Access Compliance Report

Public Rights-of-Way

(Curb Ramps)

Intersection ID: 53228	Main Street: FLEETWOOD_DR	Cross Street: MAJOR_SAMUALS_WY	Location: SW
ADA ID: 7E02AAA1CAFE	Ramp Type: Perp	Initial Pass/Fail: Fail	Overall Compliance: No
Severity Score: 21.25			
Codes/Mitigation Info/Possible Solution		Field Measurements/Component Compliance

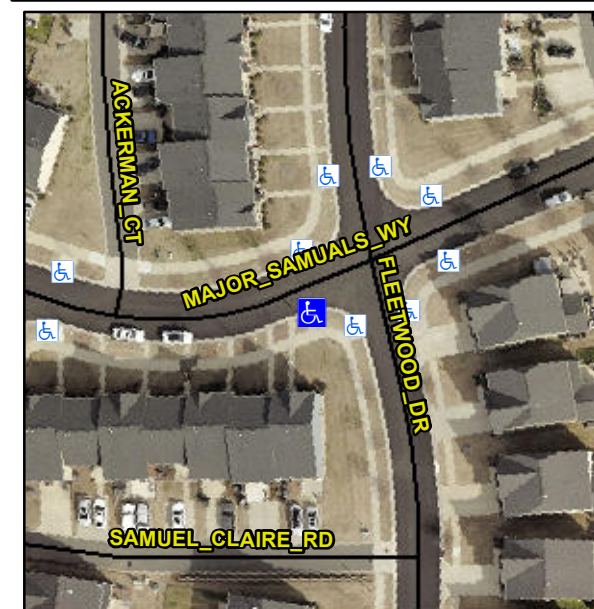
Not Found, R304.5.1, R304.2.2

Compliance	Description	Data	Compliance	Description	Data
N/A	Ramp Length (in)	90.0	No	Ramp Slope (%)	8.5
No	Ramp Width (in)	46.0	Yes	Ramp XSlope (%)	0.1
N/A	Flare Type LT	N/A	N/A	Flare Type RT	N/A
N/A	Flare Slope LT (%)	N/A	N/A	Flare Slope RT (%)	N/A
N/A	Flare Traversable LT?	N/A	N/A	Flare Traversable RT?	N/A
N/A	Landing Length (in)	N/A	N/A	DWS Provided?	N/A
N/A	Landing Width (in)	N/A	N/A	DWS Contrast?	N/A
N/A	Landing Slope (%)	N/A	N/A	DWS Length (in)	N/A
N/A	Landing X Slope (%)	N/A	N/A	DWS Full Width?	N/A
N/A	Landing Curb? (Y/N)	N/A	N/A	DWS Offset (in)	N/A
N/A	Shared Landing?	N/A			
N/A	Gutter Ponding?	N/A	N/A	Gutter Slope (%)	N/A
N/A	Gutter Lip Ht (in)	N/A	N/A	Gutter X Slope (%)	N/A
N/A	Painted X Walk1?	No	N/A	Painted X Walk2?	N/A
	X Walk 1 Direction	To N		X Walk 2 Direction	N/A
N/A	X Walk 1 Width (in)	N/A	N/A	X Walk 2 Width (in)	N/A
	X Walk 1 Slope (%)	0.7		X Walk 2 Slope (%)	N/A
	X Walk 1 X Slope (%)	0.1		X Walk 2 X Slope (%)	N/A

Remove & Replace Entire Ramp.
